PRAIRIE ISLAND NUCLEAR GENERATING PLANT
Docket Nos. 50-282 License Nos. DPR-42
50-306 DPR-60

Auxiliary Feedwater Systems

REVIEW OF NRC RECOMMENDATIONS
RELATED TO PRAIRIE ISLAND AFW SYSTEMS

Auxiliary Feedwater System
Prairie Island
Figure 1

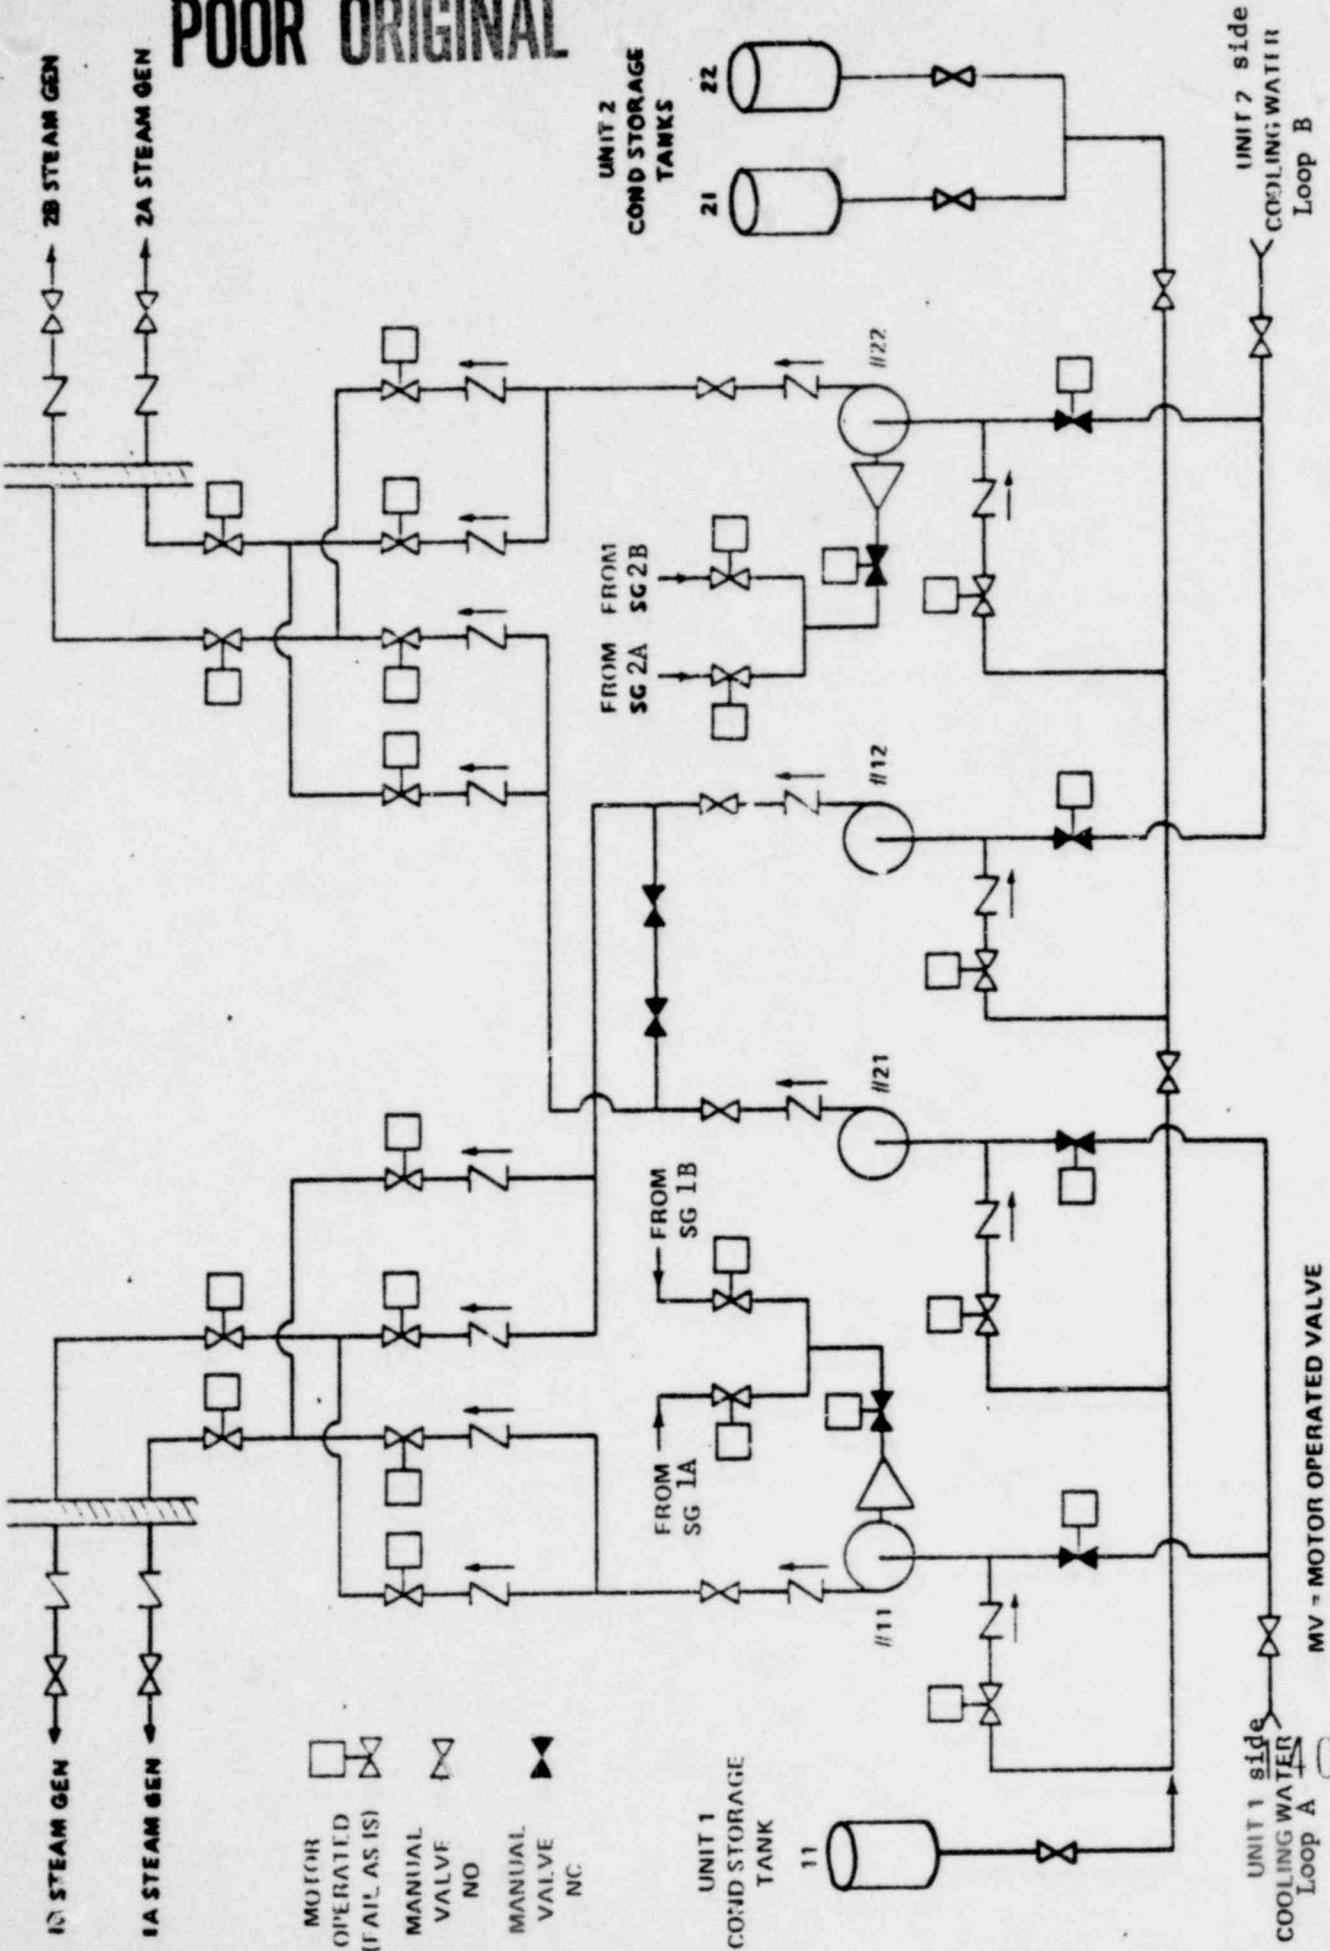
"Licensees having plants with unprotected normal AFW system water supplies should evaluate the design of their AFW systems to determine if automatic protection of the pump is necessary following a seismic event or a tornado. The time available before pump damage, the alarms and indications available for the control room operator, and the time necessary for assessing the problem and taking action should be considered in determining whether operator action can be relied on to prevent pump damage. Consideration should be given to providing pump protection by means such as automatic switchover of the pump suction to the alternate safety-grade source of water, automatic pump trip on low suction pressure or upgrading the normal source of water to meet seismic Category I tornado protection requirements."

The normal source of water, the condensate storage tanks, do not meet seismic category I tornado protection requirements. There is redundancy of these tanks as shown in Figure 1. It is unlikely that the seismic or tornado event could affect all 3 tanks because of location.

FIGURE 2

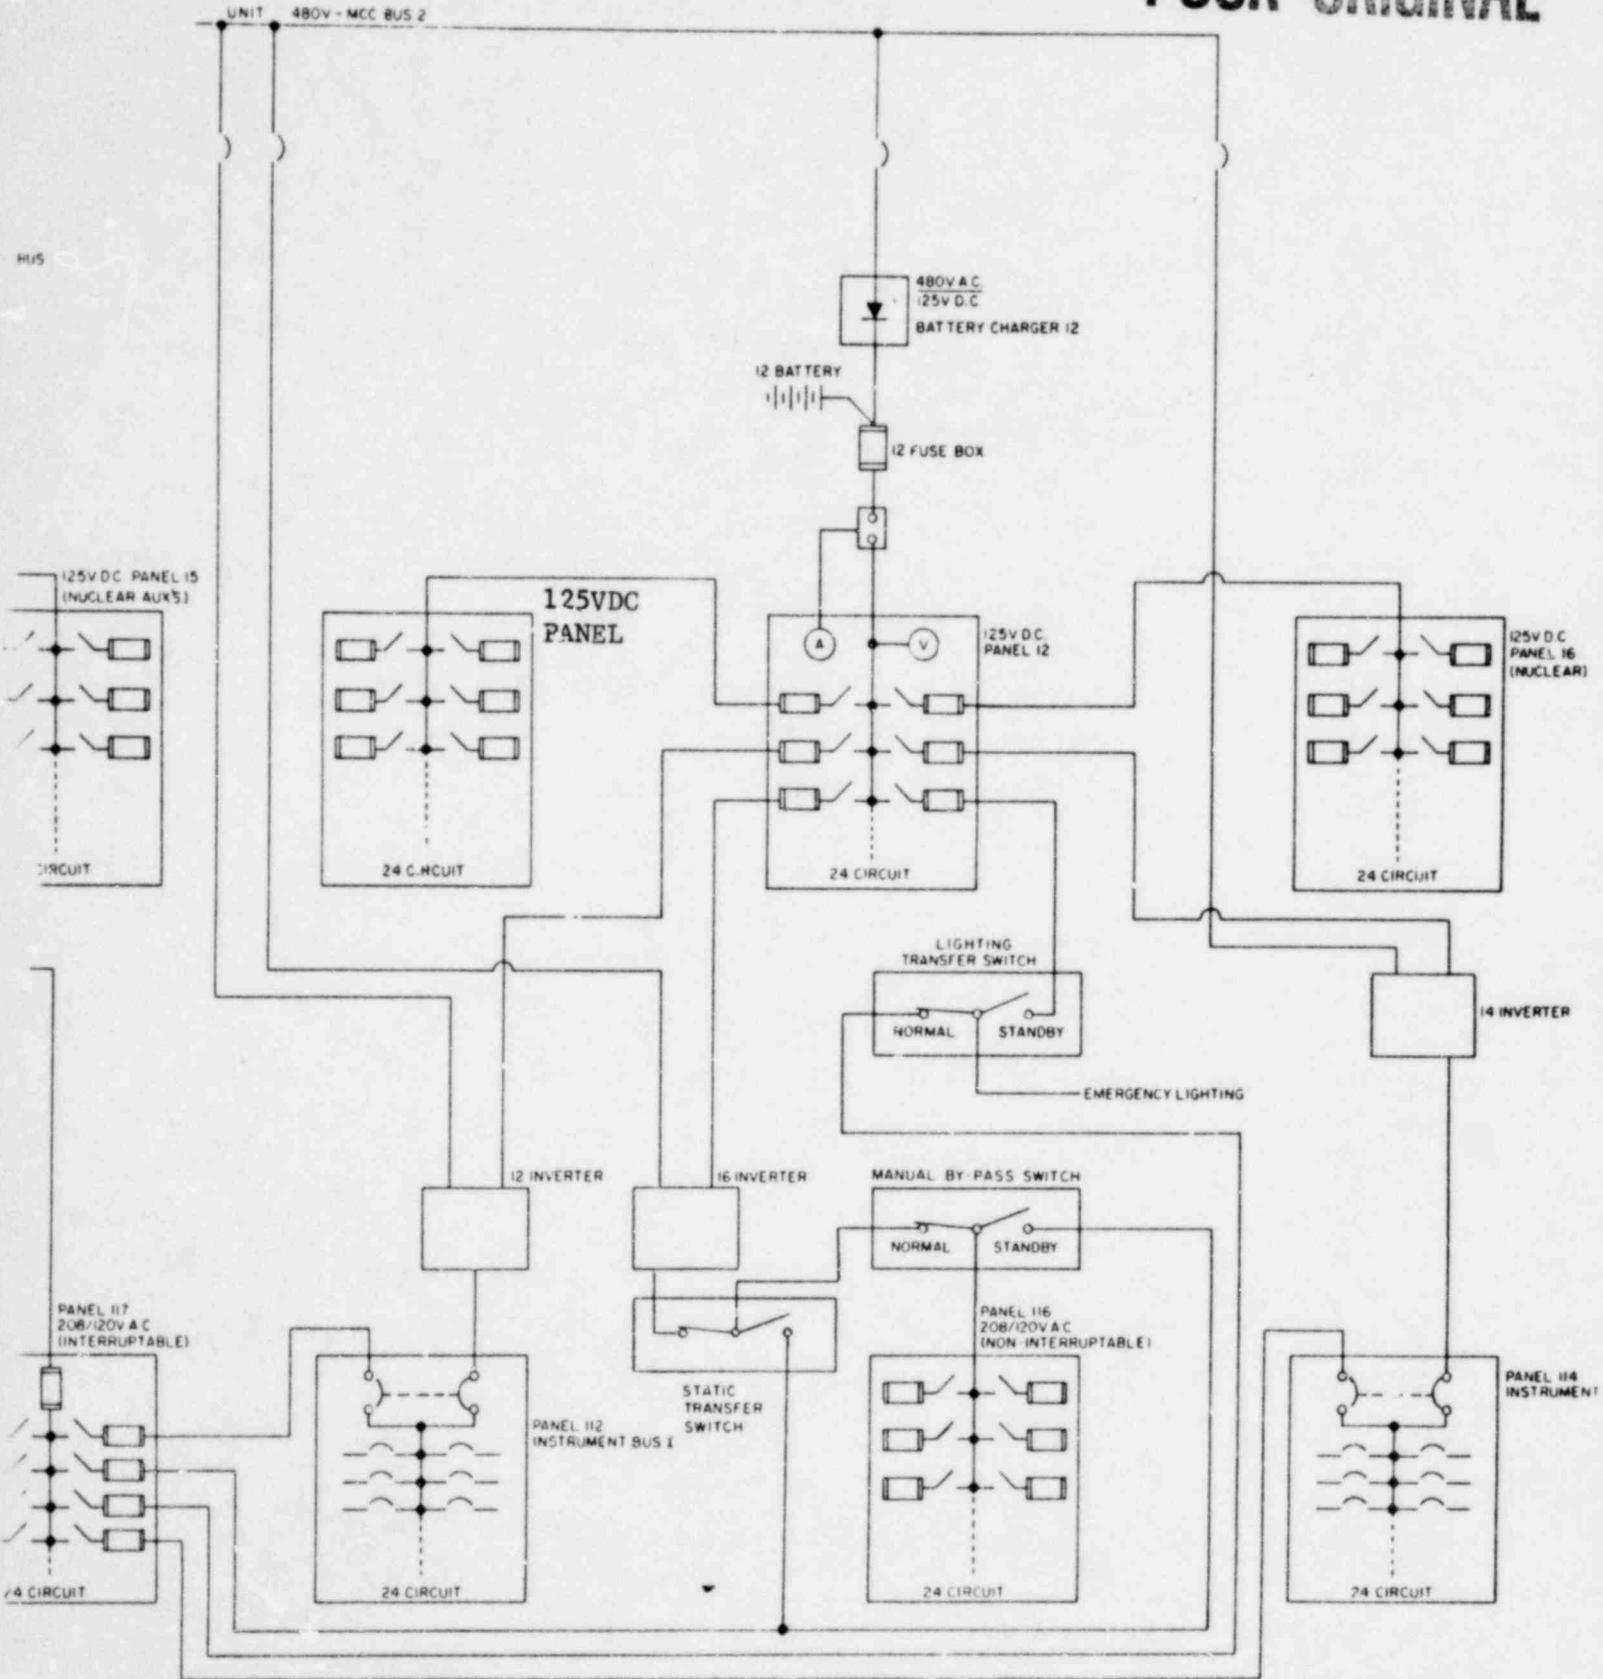
The as-built plant should be capable of providing the required AFW flow for at least two hours from one AFW pump train independent of any alternating current power source. If manual AFW system initiation or flow control is required following a complete loss of alternating current power, emergency procedures should be established for manually initiating and controlling the system under these conditions. Since the water for cooling of the lube oil for the turbine-driven pump bearing may be dependent on alternating current power, design or procedural changes shall be made to eliminate this dependency as soon as practicable. Until this is done, the emergency procedures should provide for an individual to be stationed at the turbine-driven pump in the event of the loss of all alternating current power to monitor pump bearing and/or lube oil temperatures. If necessary, this operator would operate the turbine-driven pump in an on-off mode until alternating current power is restored. Adequate lighting powered by direct current power sources and communications at local stations should also be provided if manual initiation and control of the AFW system is needed.

During events such as a loss of all AC emergency lighting would be provided from the Class 1E DC distribution system (Figure 2).
